**Historic Review  
Notice of Decision Staff Report  
October 23, 2019**

- FILE NO.:** GLUA-19-00029/HR 19-04: Historic Review Board review of a new single family home in the Canemah National Register Historic District.
- HEARING DATE:** October 22, 2019

- REQUEST:** New single family home in the Canemah National Register Historic District.
- DECISION:** On October 22, 2019, after reviewing all of the evidence in the record and considering all of the arguments made by the applicant, opposing and interested parties, the Oregon City Historic Review Board voted 4-0 to approve the proposal with conditions. The Oregon City Historic Review Board adopted as its own the Staff Report with findings and Conditions of Approval for File Number HR 19-04. The complete record for the Historic Review Board decision is on file at the Planning Division.

*Rendering*

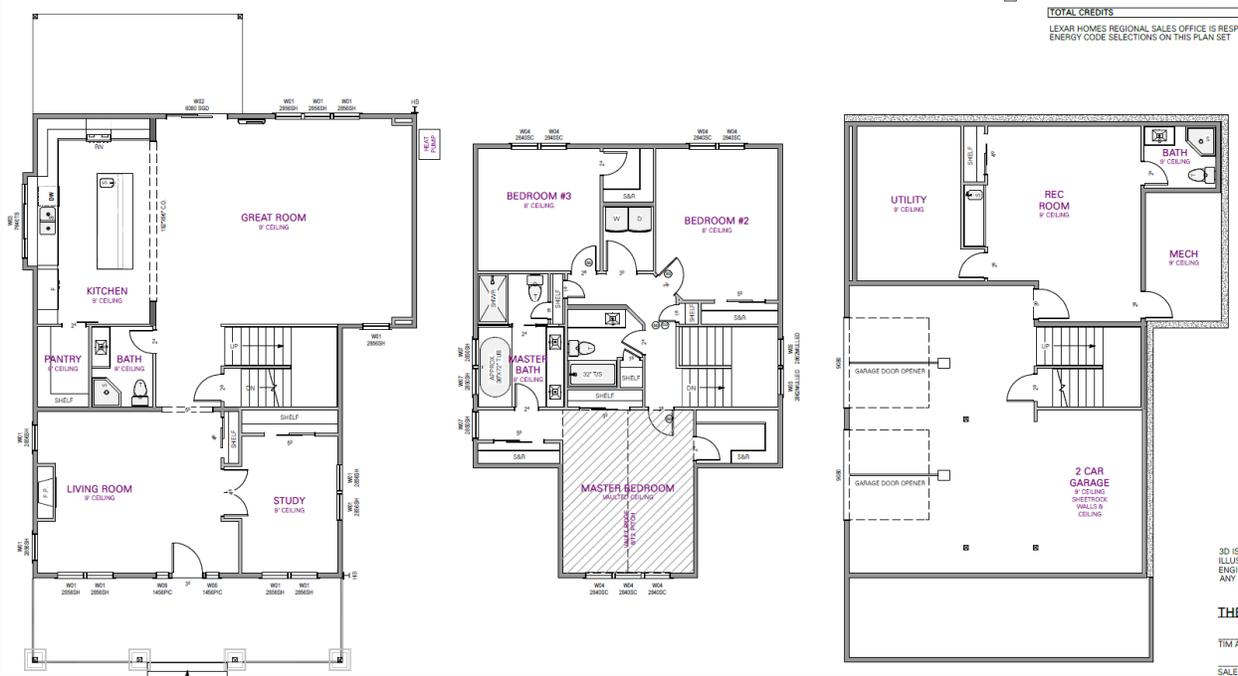
The house is proposed to face 4<sup>th</sup> Avenue. The home is proposed to be set back more than 35 feet from the 4<sup>th</sup> avenue rockery wall to allow for more separation between the wall and the home.

Two new rock retaining walls are proposed on site along the back side of the home and the uphill side of the driveway area. The height of these walls is not indicated on the plans. The maximum height shall be limited to 5 feet. Any additional natural rockery walls that are less than 4 feet are allowed on the site without further Historic Review Board review. The proposed retaining walls shall be a rockery wall, or utilize concrete or natural basalt veneer.

The applicant has not provided information on grading; the site is within the geologic hazard overlay and some grading is anticipated. Page 34 of the design guidelines states that extensive regrading of the lot to raise or lower the main level of the house is not allowed. The applicant shall minimize grading and comply with any applicable standards in the geologic hazard overlay zone.

The applicant proposes to remove two 36” Douglas Fir trees and 7 to 9 maples of various sizes. Three large firs are proposed to remain, along with 3 maples on site and several more maples in the 4<sup>th</sup> street right-of-way between the property and the 4<sup>th</sup> street pavement. Page 24 of the design guidelines call for replanting to preserve tree canopy. With the retention of several trees, the canopy will be greatly

*request through a vote of its general membership or board at a duly announced meeting prior to the filing of an appeal.*

7. Proposed retaining walls shall not exceed five feet in height. (P, DS)

Floor plans

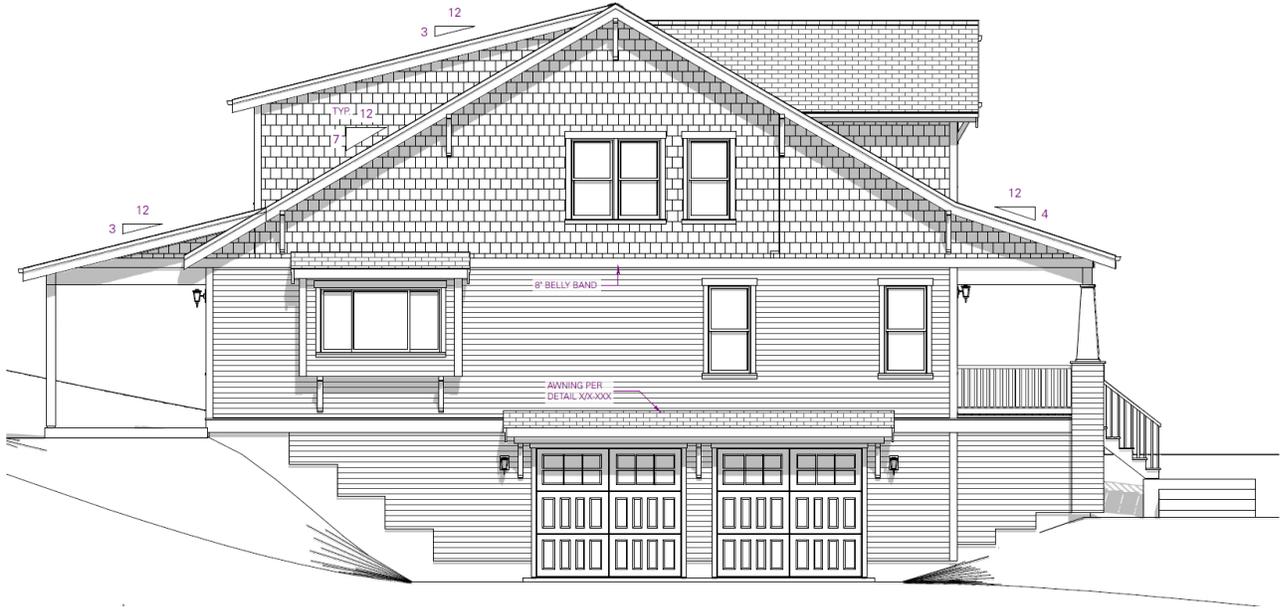
The floor plan is a rectangular shape with a footprint of approximately 1580 square feet. A public comment made at the September 2019 HRB meeting indicated that the size of the home was much

The applicant states: “The main level will be 1613 sqft and the top floor will be 1079 sqft with the lower level having a bonus room of 567 sqft.” Thus, the total square footage is 2692 plus the 567sf basement. This overall size is likely on the larger end for the historic district. Many of the newer homes in Canemah are within this ballpark size, and some of the historic homes may be similar in overall square footage as

The height to roof peak is 25 feet and width of the home is 31 feet at the front and 39 feet on the rear. This ratio is approximately 1:1.5 as described in the guidelines.

The depth of the home is approximately 46 feet, making the height to depth ratio less than one.

The side-facing gable roof pitch is proposed as 7:12 with the front porch and rear shed dormer roofs are at 3:12. The front dormer has a gable roof front-facing with an 8:12 pitch. The 7:12 pitch is greater than the guideline for 6:12 maximum, and is greater than most Canemah bungalows. A lower pitch would reduce the height and massing of the home, although the HRB may find that the proposal is consistent with traditional bungalows in the region.

The home includes a prominent front porch that extends the width of the home. The front porch posts are thick and tapered in the typical bungalow style. The stairs to the front porch appear to number about 9 steps, which is more than allowed under the guidelines for exterior stairways on Page 48, which says exterior stairs exceeding five feet in height at the front of buildings are not allowed. The topography of the site is steep and the applicant has proposed a front stair that turns 90 degrees, which helps to reduce the impact of the staircase height. The applicant shall modify the grading plan or house design such that the stairs facing 4<sup>th</sup> Avenue do not exceed 5 feet in height, and shall not increase the number of stairs beyond what is shown in the plans.

The front façade is symmetrical due to window variation and left side wing, and the front porch is symmetrical. The porch is full width and does not wrap around the home. The home includes a single dormer with an 8:12 roof pitch. While this pitch is not particularly low as discussed in the guideline, it appears to fit the overall home aesthetic.

Windows on the front facade include paired 1 over 1 double hung windows on each side of the front door. The dormer is proposed to have a bank of three windows. It is not clear if these are casement windows or another type. Slider windows are not permitted.

Windows on the sides are paired 1:1 double hung. Rear windows are paired 1 over 1 and single lite windows.

6. The applicant shall modify the grading plan or house design such that the stairs facing 4<sup>th</sup> Avenue do not exceed 5 feet in height, and shall not increase the number of stairs beyond what is shown in the plans. (P)

Exposed siding proposed under the front porch shall not be more than one foot taller than shown in plans. Any changes exceeding one foot must be reviewed by the Historic Review Board. Landscaping shall also be utilized to visually shield the massing under the porch and on side elevations. A maximum of ten shrubs with minimum mature height of 5 feet may be required, with final number and locations selected by staff after construction.

Exposed siding proposed under the front porch shall not be more than one foot taller than shown in plans. Any changes exceeding one feet must be reviewed by the Historic Review Board.
